FRAMING PLAN - BRIDGE 87S

FRAMING PLAN - BRIDGE 87N

OUT FOR APPROVAL	3-26-01										
OUT FOR APPROVAL											
ISSUED TO SHOP											
FIELD & OFFICE											
REV.	REMARKS	DATE	DWN	CHK	APP	Q.A.	NO.	DIA.	LGT	TYPE	WASHER
MATERIAL:	ELECTRODES:	HOLES:		SHOP BOLTS:							
M270 GR. 50W		15									
		1/8		U.N.							
SURFACE PREP. & PAINT: NONE											
DESCRIPTION:	CALCULATION PLAN				DRAWN BY	DATE					
JOB:	I-89 OVER VT 104				JAK	3/12/01					
	BRIDGE 87S & 87 N				CHKD BY						
	I-89 IMPROVEMENTS				JB	3/22/01					
	FAIRFAX FRANKLIN COUNTY				APPROV BY						
					SUPERVISOR	M. J. GATTI					
PROJ NO.	IM 089-3(27)										
CUSTOMER: VERMONT AGENCY OF TRANSPORTATION											
CASCO BAY STEEL STRUCTURES, INC.				JOB NO.	DRG. NO.						
75 SPRING HILL ROAD				131	E1						
PHONE (207) 282-7360				SACO, MAINE 04072	REV. △						
FAX. (207) 282-1179				445

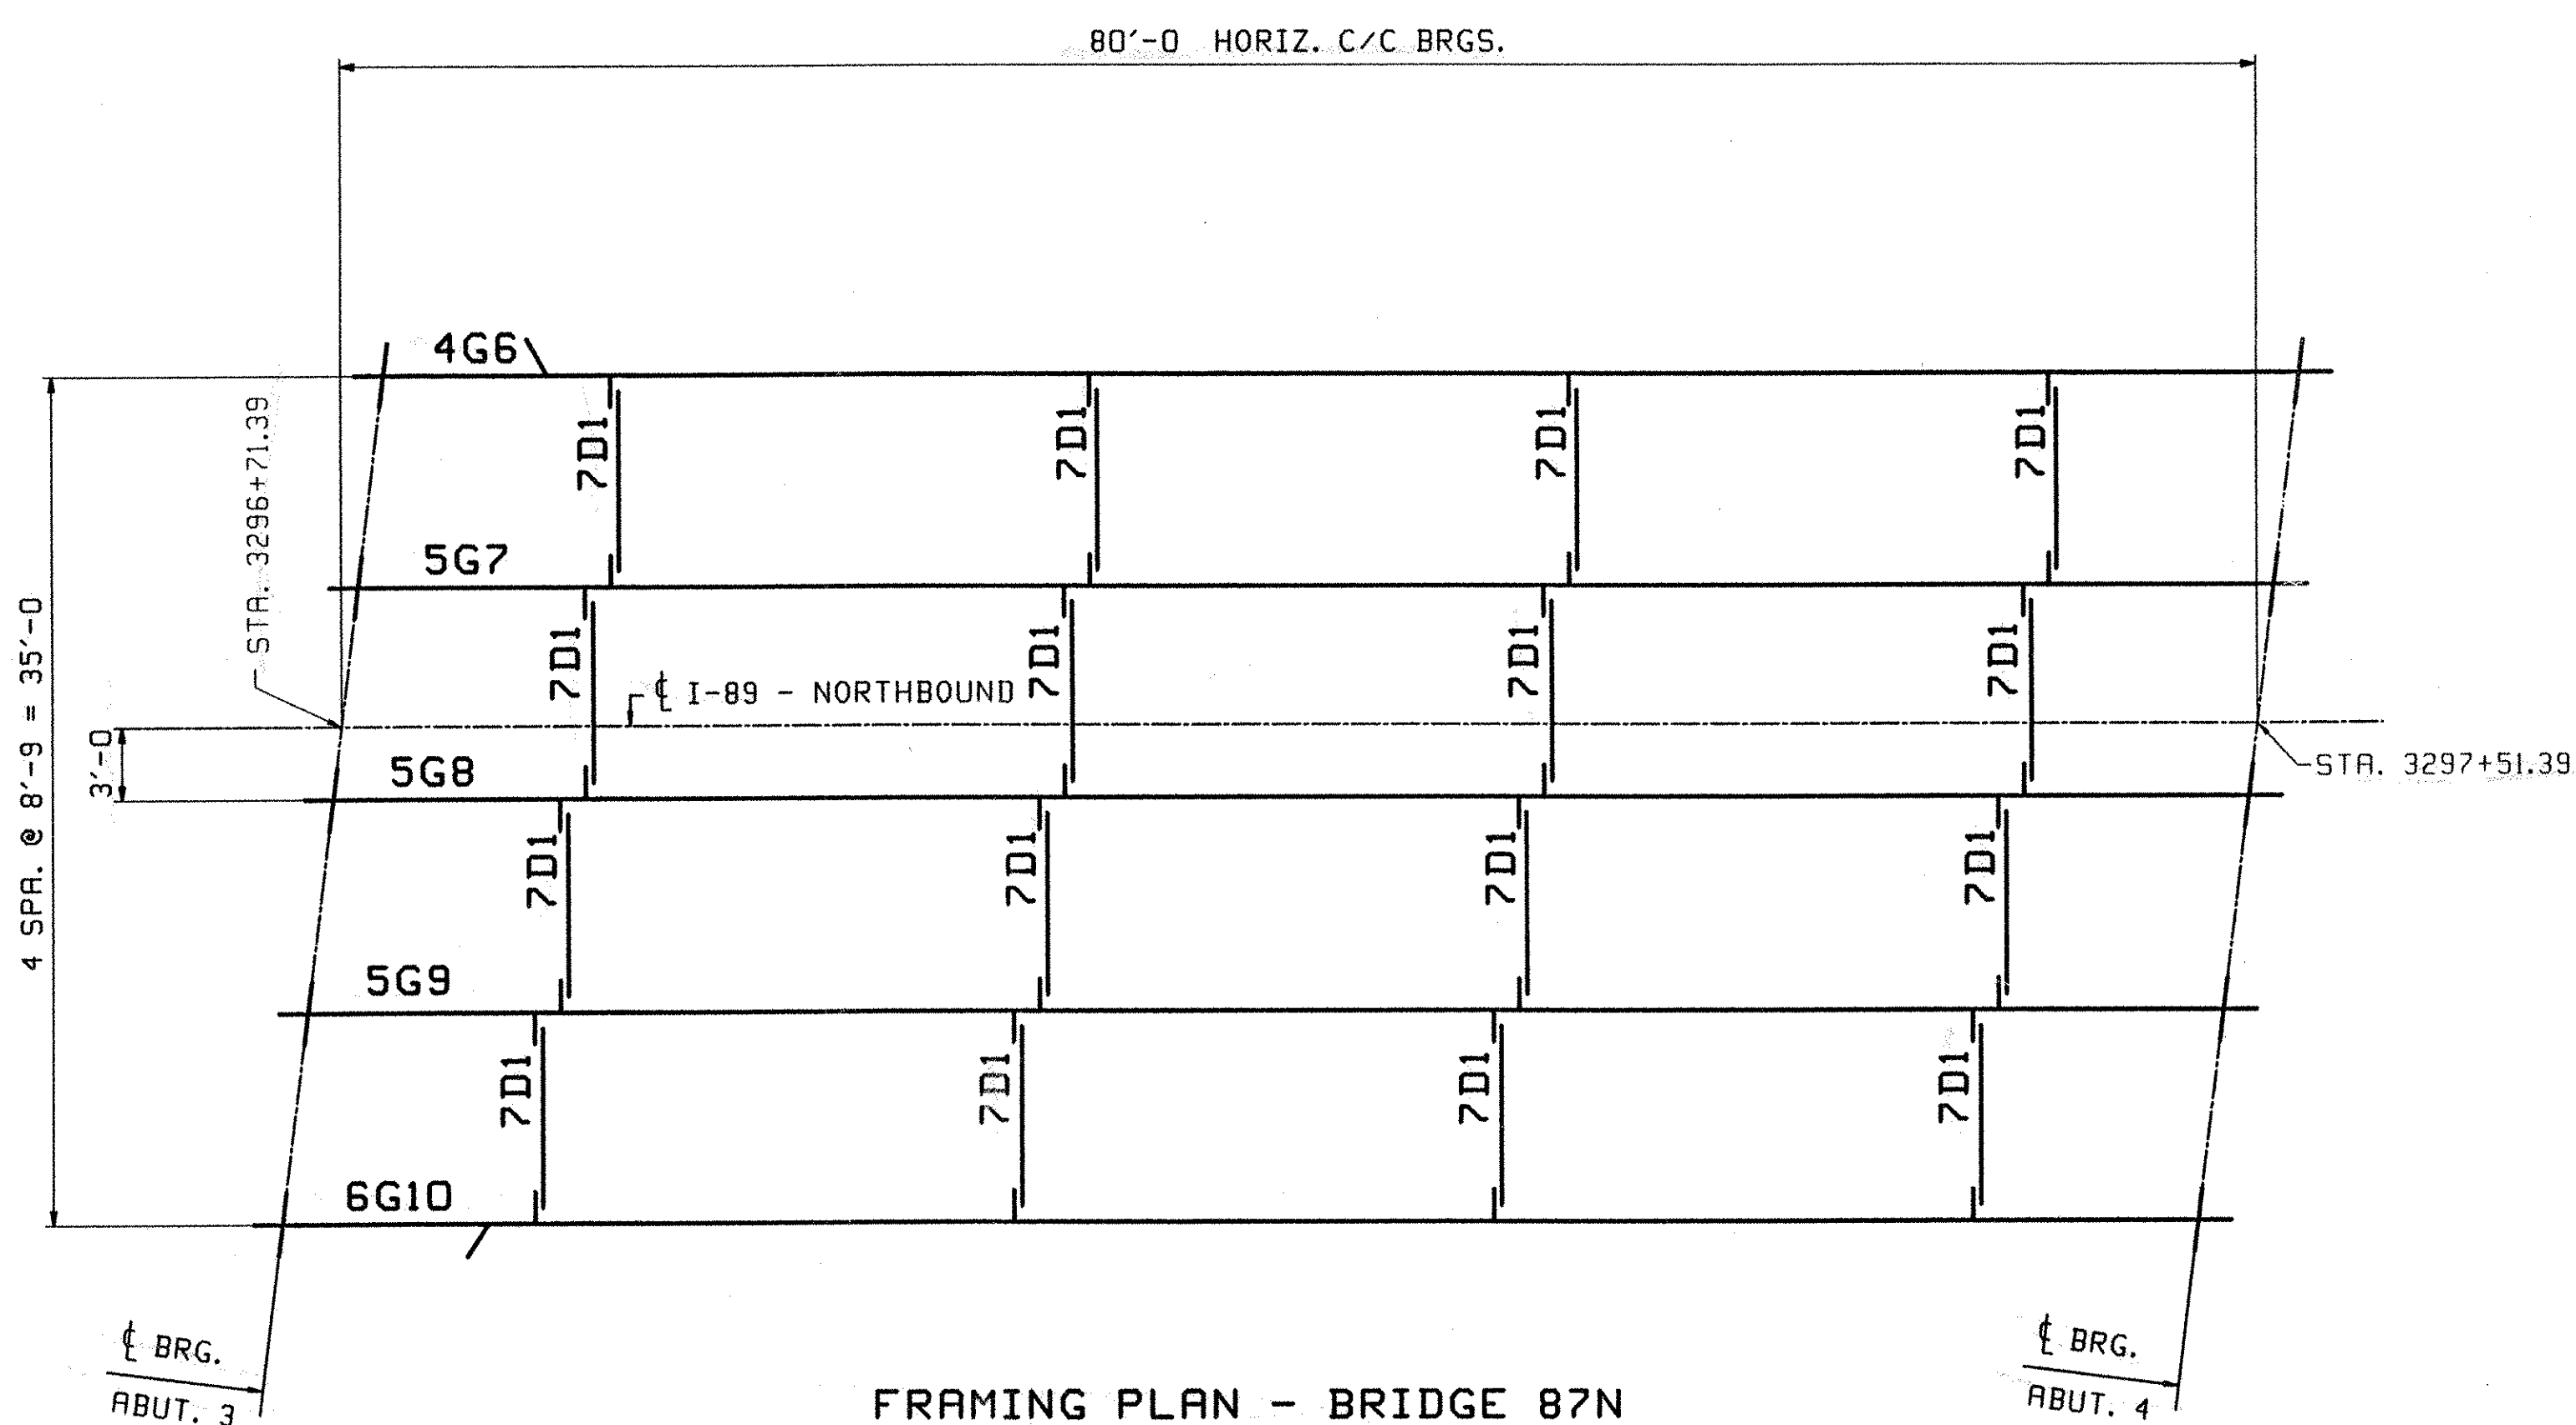
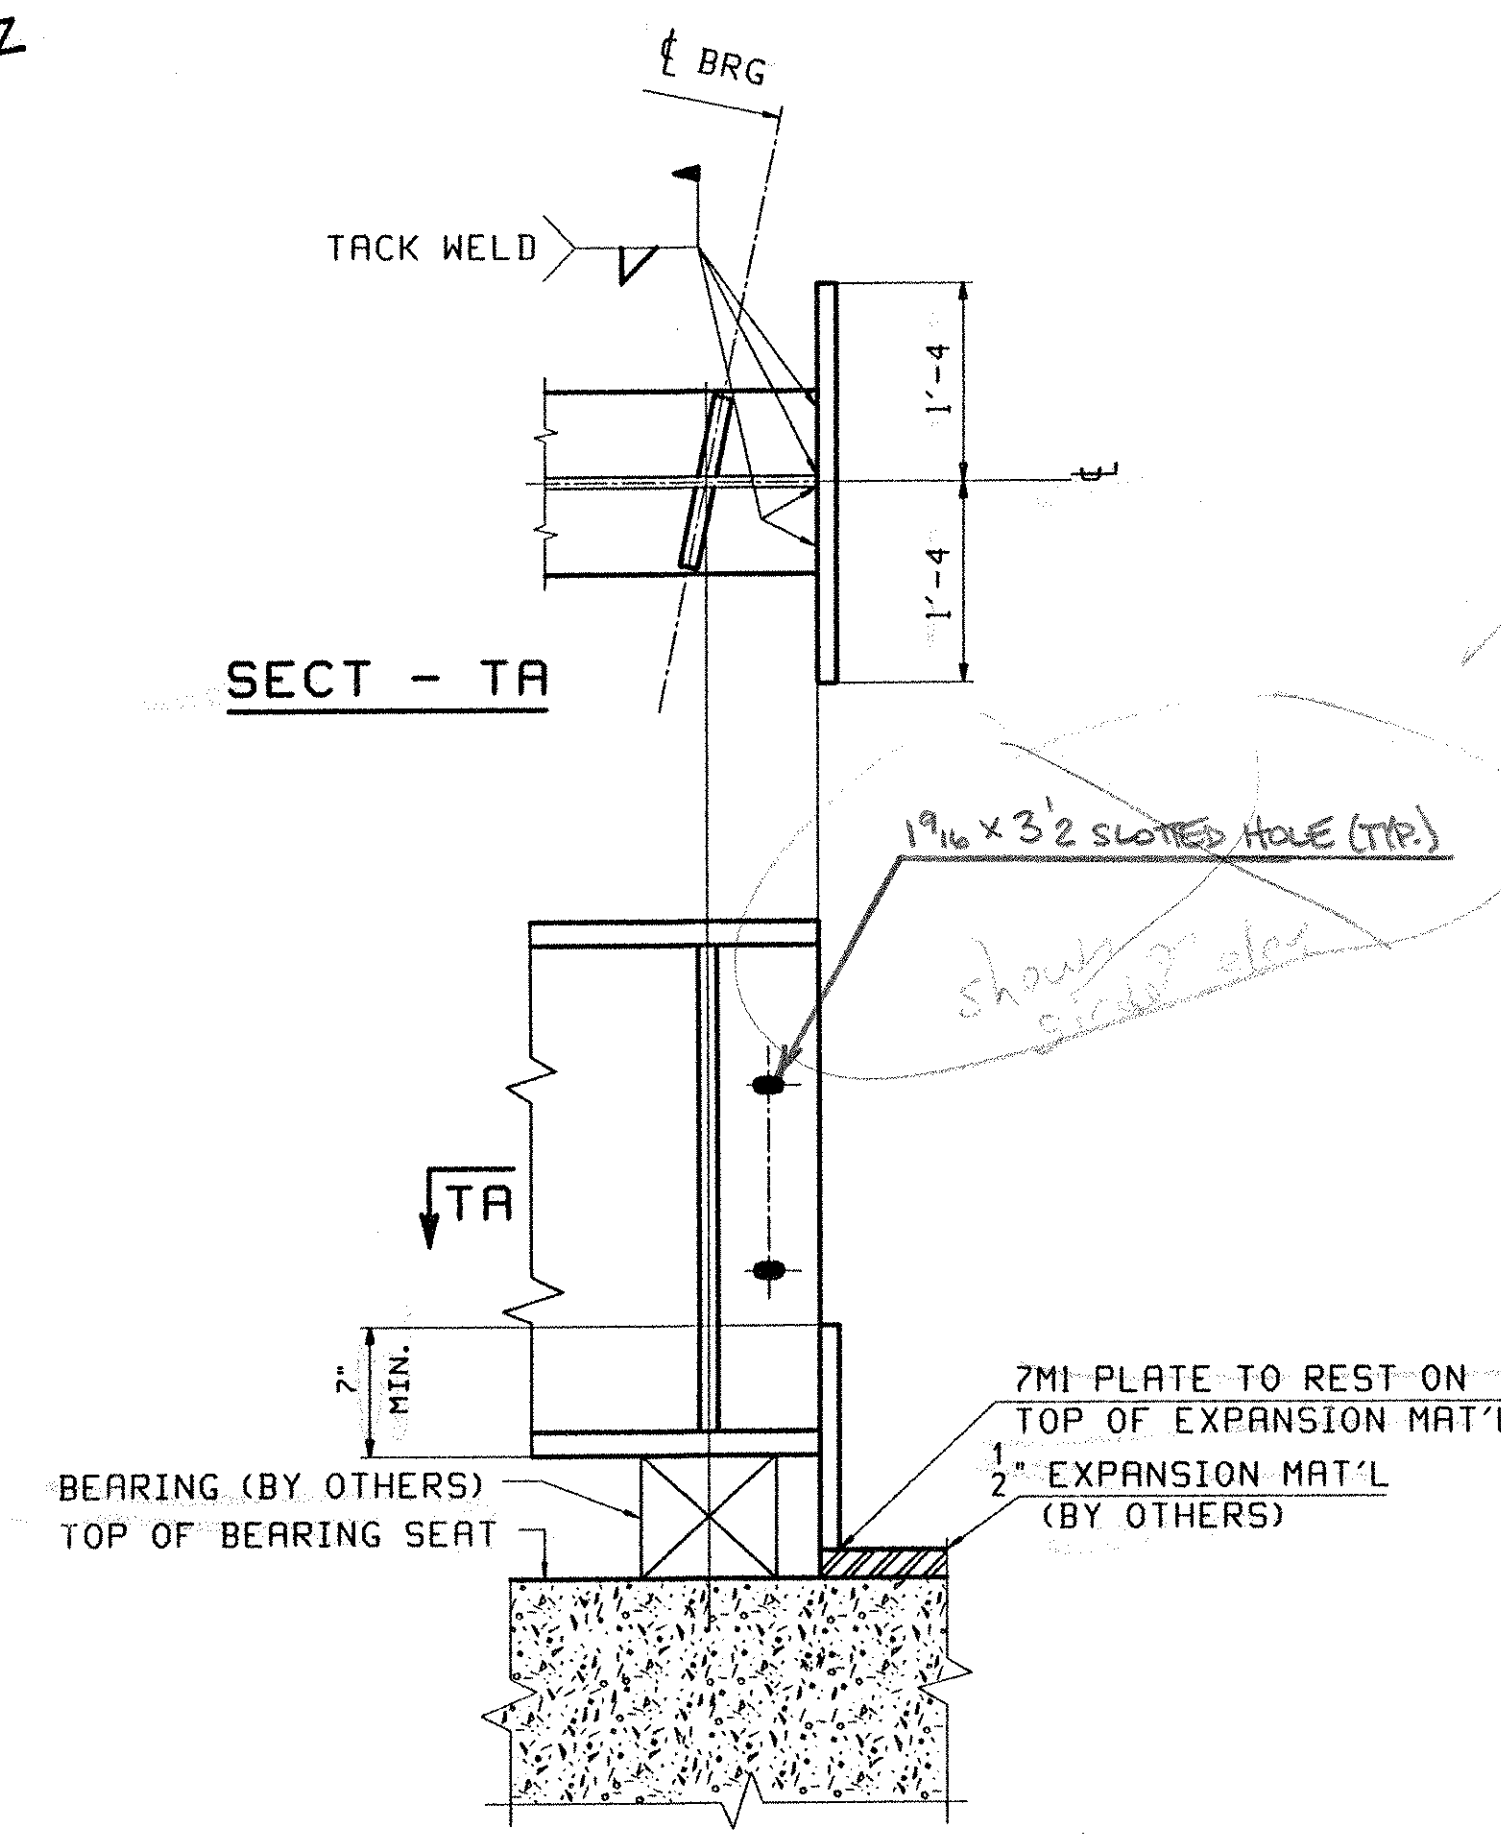
VAOT
RECEIVED
CHK'D BY *[Signature]* OK'D BY *[Signature]*
3-30-01 4-18-01
MAR 29 2001
RESUBMIT APPROVED ✓ AS NOTED
BY *[Signature]* DATE 4-18-01
